Divine Intimates Ltd

10th January 2018

Observation

Paucity of details in As-Built drawings

Sub-beam at 5th floor

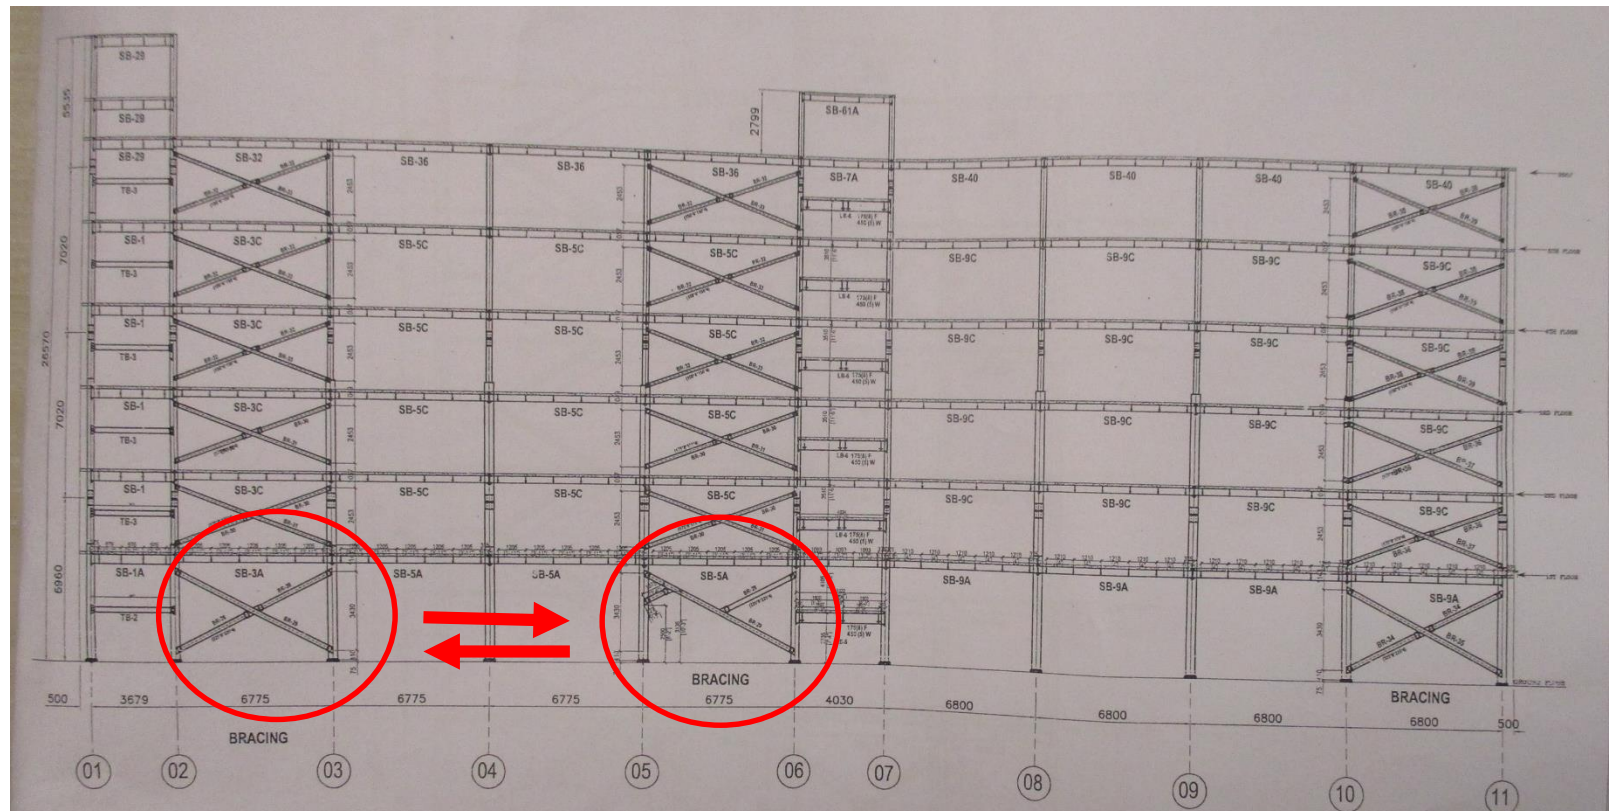
Details information were not found for section 13 (Lift core)

Sub-beam at 5th floor are not similar with typical floor. Sub-beam layout for 5th floor was not found in as built drawings. Also Sectional details of grid 13 was not available in provided drawings .

Item No.	Observation	Recommended Action Plan	Recommended Timeline
1	Paucity of details in As-Built drawings	Building Engineer to survey as-built structure and prepare accurate as-built survey information with connection details for the building.	6-weeks
2	Paucity of details in As-Built drawings	Provide details information for over head water tanks.	6-weeks

Cross section of Grid-A

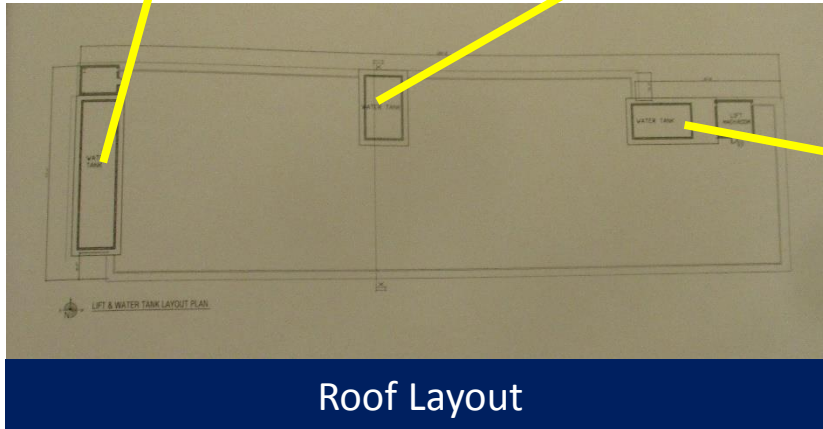
Bracing pattern of marked two location was interchanged on site.
